6631B-08

S E R V I C E N O T E

Agilent 6631B DC Power Supply

On faster computers, when programming over GPIB, a random error will occur.

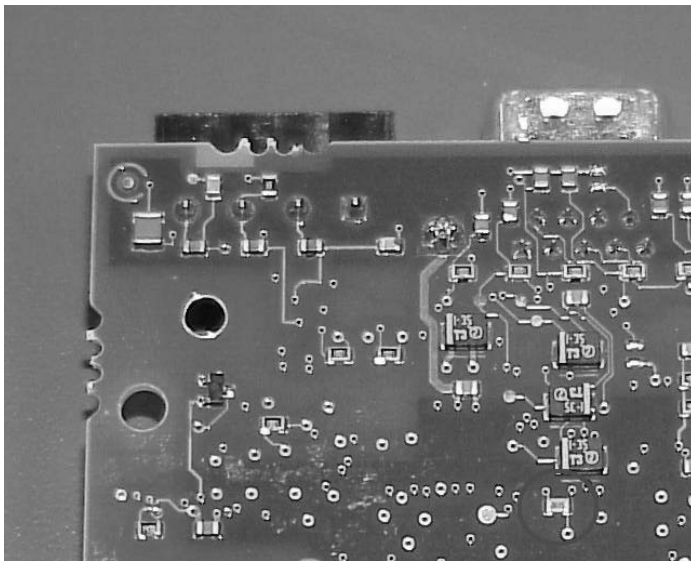
When programming a unit over GPIB, a random error -113 (“Undefined header”) will appear on the unit. This error can be read back via the front panel or over the GPIB bus.

Change resistor R1246 (see picture for location) from 511 Ohms to 100 Ohms (part number 0699-3058). This requires un-soldering and soldering a surface mount component and can be very difficult. This does not require re-calibration.

Replace the entire GPIB assembly (part number 5063-4841) with a newer one that has the 100 Ohm resistor. This will require the unit to be re-calibrated.
